Additional Information Response:

Note: The proposed development has been revised. The number of proposed units has been reduced from 2 to 3. The revised proposal is for the construction of one 4 bed detached residential unit and the reinstatement of existing unit from child care care building to a 4 bed semi-detached residential unit.

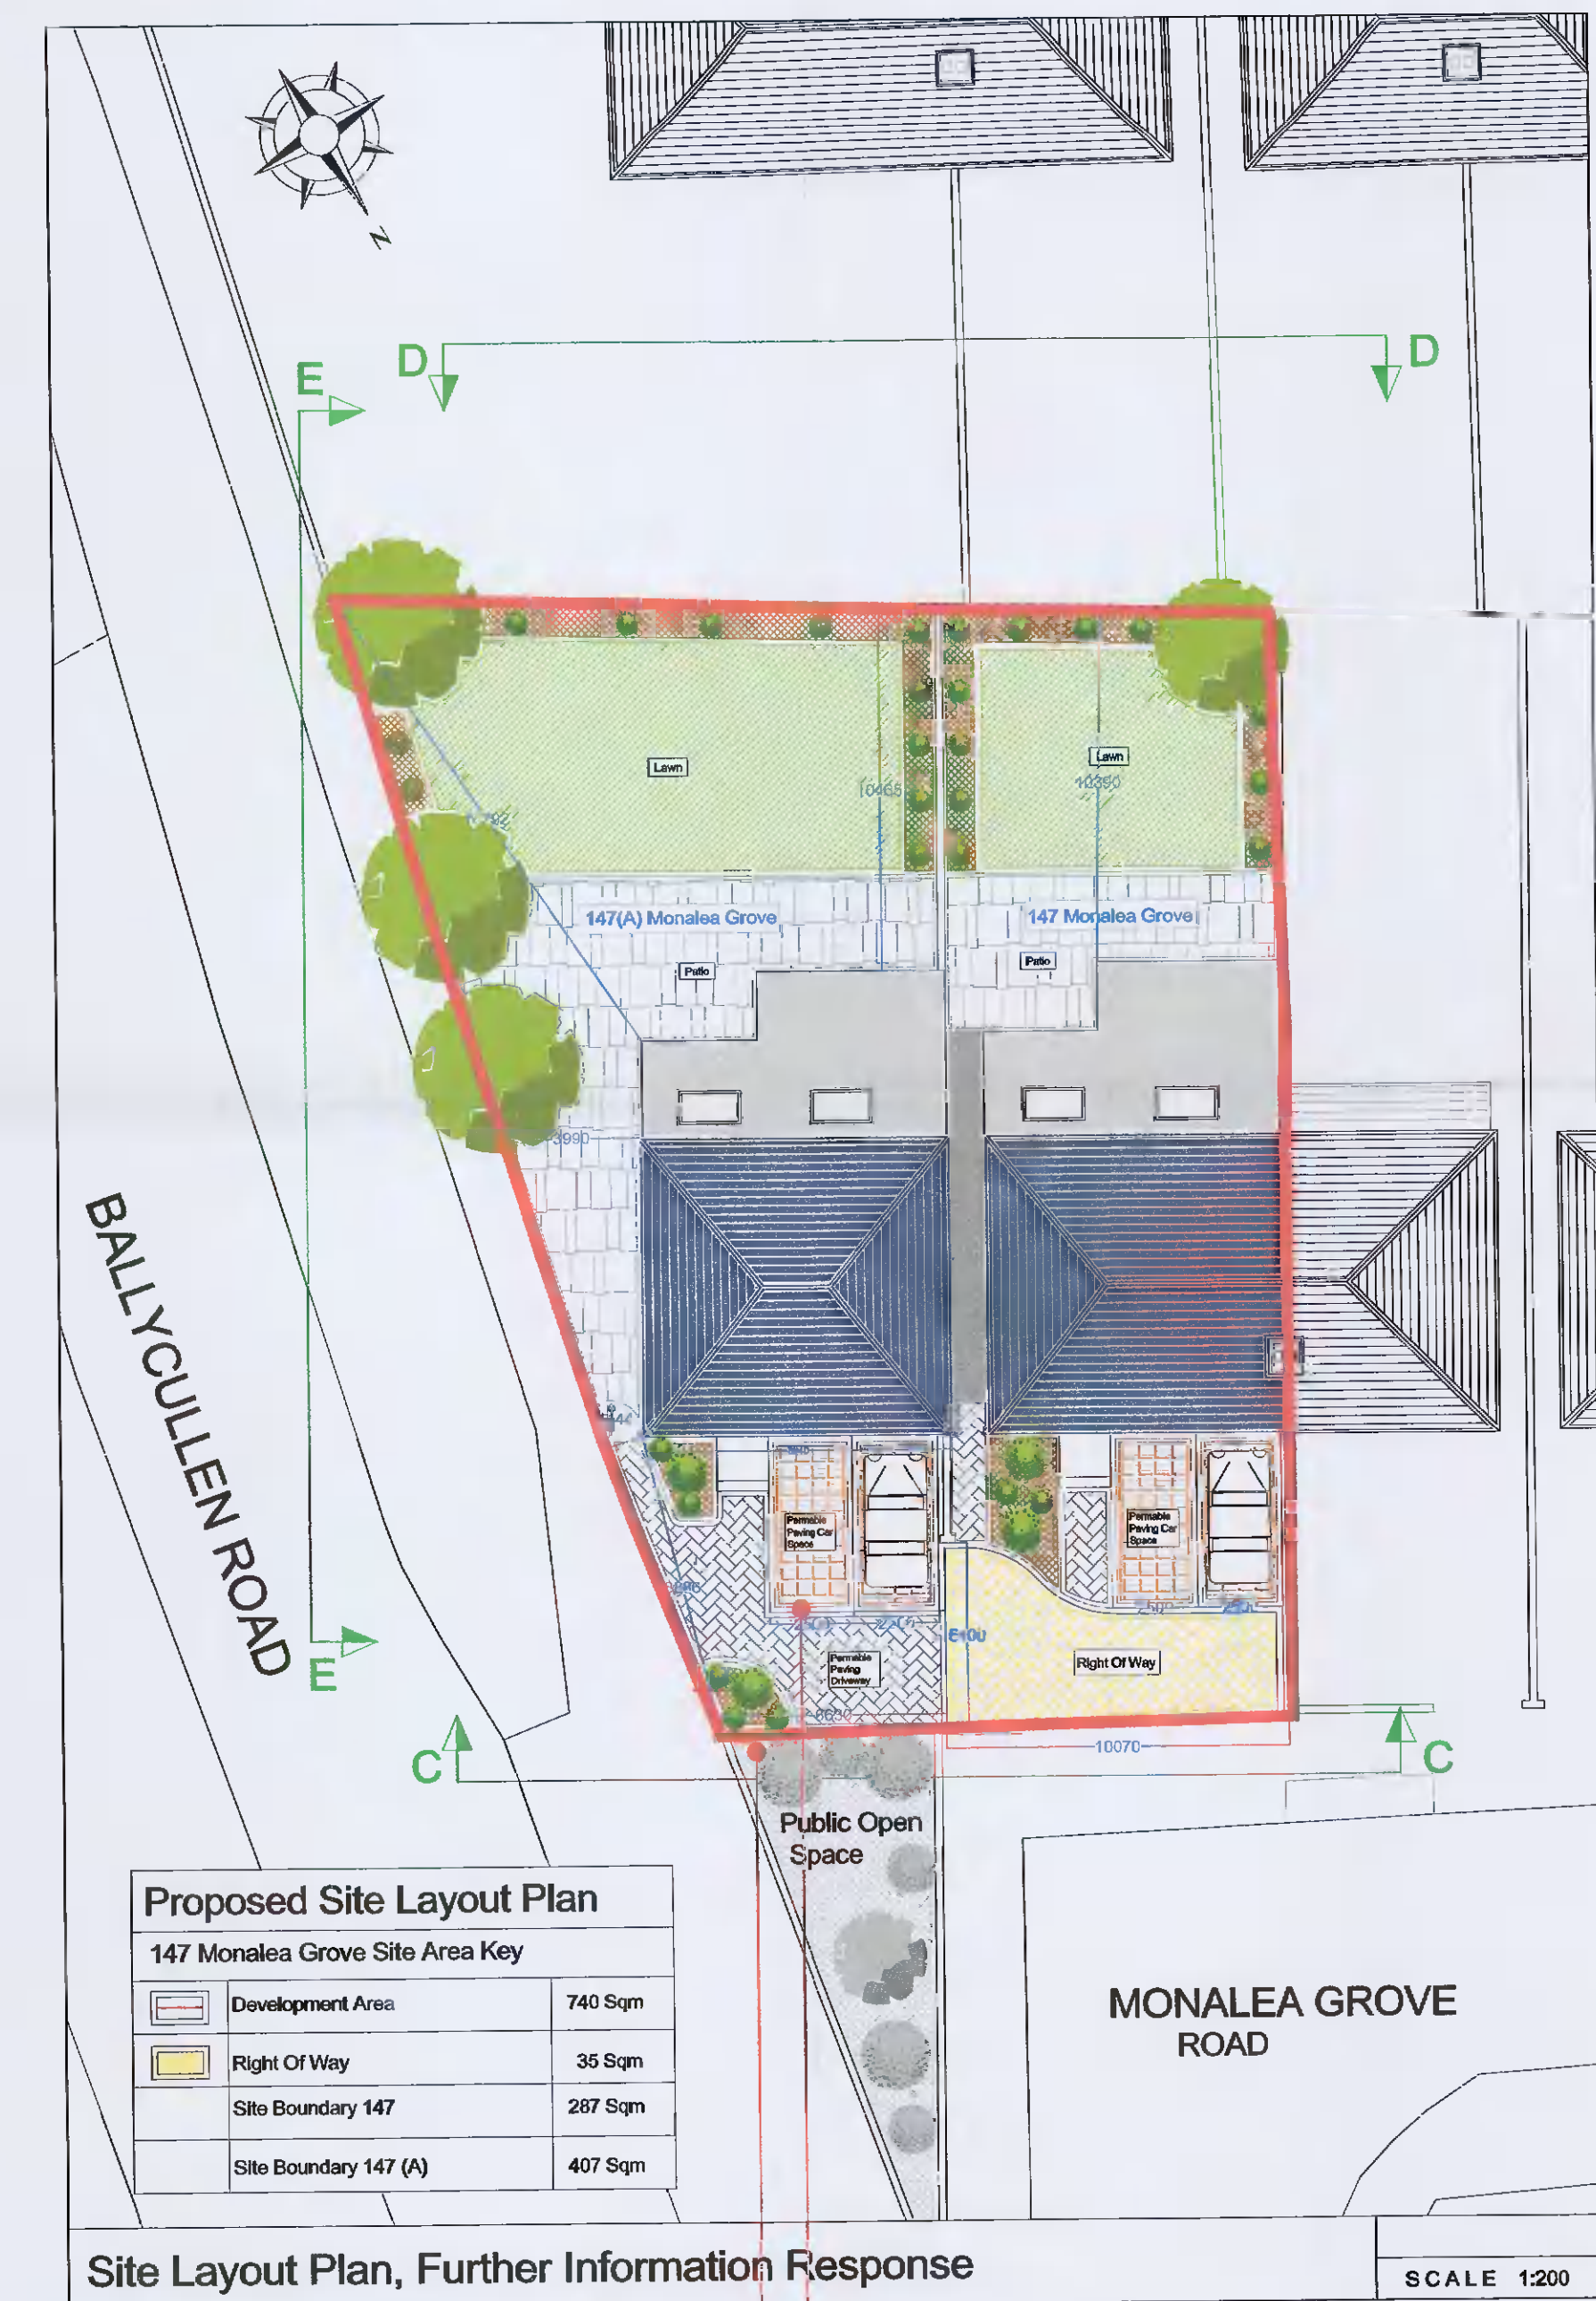
Request:
1. Development should not encroach on publicly owned planted space directly north of the site

Request:
2(a) The applicant is requested to submit a revised layout increasing the parking arrangement to up to 2 on-curtlidge car parking spaces for each dwelling
2(b) The applicant is requested to consider providing separate vehicle access to each dwelling

Response:
1. Development does Not encroach on publicly owned planted space directly north of the site. See Revised Site Layout Plans & Ordnance Survey Maps which clearly shows the site boundary line for proposed development and the boundary line for the publicly owned planted space

Response:
2(a&b) The proposed car parking arrangement is for the allocation of two separate car parking spaces per dwelling. Each dwelling is accessed via a shared surface 'way leave' for vehicular access
